STATE OF WASHINGTON
DEPARTMENT OF ECOLOGY
PO Box 47775 • Olympia, Washington 98504-7775 • 360-407-6300
Call 711 for Washington Relay Service • Persons with a speech disability can call 877-833-6341

Re: City of Olympia's Response to Ecology's Comments

- **Site Name:** Solid Wood Inc.
- **Site Address:** 700 W Bay Drive NW, Olympia, WA 98502-4838
- **Facility/Site No.:** 94656838
- **Cleanup Site ID:** 4228
- **Agreed Order No.:** DE-08-TCPSR-5415

The Washington State Department of Ecology (Ecology) has reviewed your response¹ to Ecology's comment letter² on the draft Remedial Investigation/Feasibility Study (RI/FS) Report (report)³ for the Site. Attached is a table that provides Ecology's responses to your responses. Also, listed below are additional comments on the Report.

Figure 1: 1961 Air Photo showing historical log storage and area needed for sediment characterization for wood waste impacts.

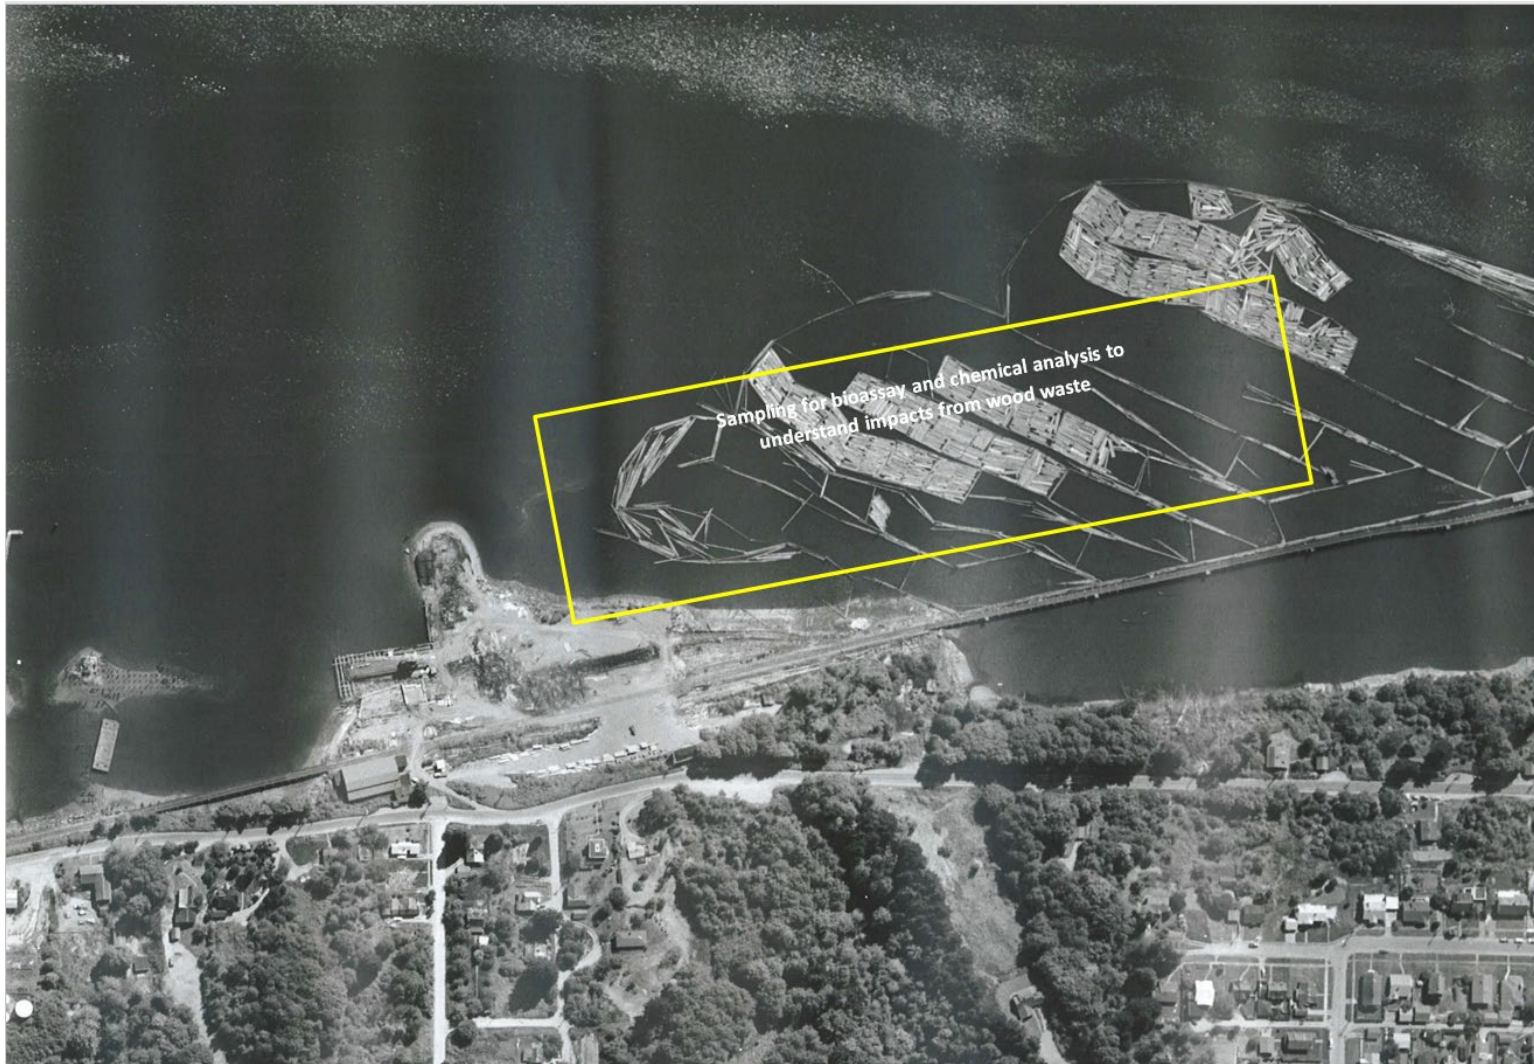
2.	<p>Section 1: Introduction, Footnote 3: Same comment as above.</p>	<p>See previous response.</p>	<p>See above.</p>
3.	<p>Section 2.4, Potential Contaminant Sources: This sections fails to describe what contaminants are associated with the “potential contaminant sources”. As such, it is unclear to the reader what contamination may be encountered by potential receptors (e.g., cross reference in Section 2.7).</p>	<p>Section 2.4 Potential Contaminant Sources refers to Table 2-1 which identifies potential containment sources and the associated release mechanisms and the typical contaminants associated with the source and release mechanism. This table provides an overview of the contamination that may be encountered on the Site. Figure 2-3, also referenced in Section 2.4, identifies the locations of the potential contaminant source areas. Text will be revised to include the following: Contaminants associated with the potential contaminant source areas and release mechanisms identified in Table 2-1 and in Figure 2-3 include the following:</p> <ul style="list-style-type: none"> • Heavy metals 	<p>Thank you for agreeing to add text in response to our comment. Your proposed text is a concise summary of the contaminants. However, we recommend that you also include in the text a brief summary of the possible contaminant sources and the release mechanisms that are shown in the table. Please also revise this section to include a discussion on the following potential sources to sediment and revise Figure 2.3:</p> <ul style="list-style-type: none"> • Historical in-water log storage areas as a source of wood waste to sediment. Based on historical maps, in-water log storage occurred for wood processing at this Site (see attached Figure 1).
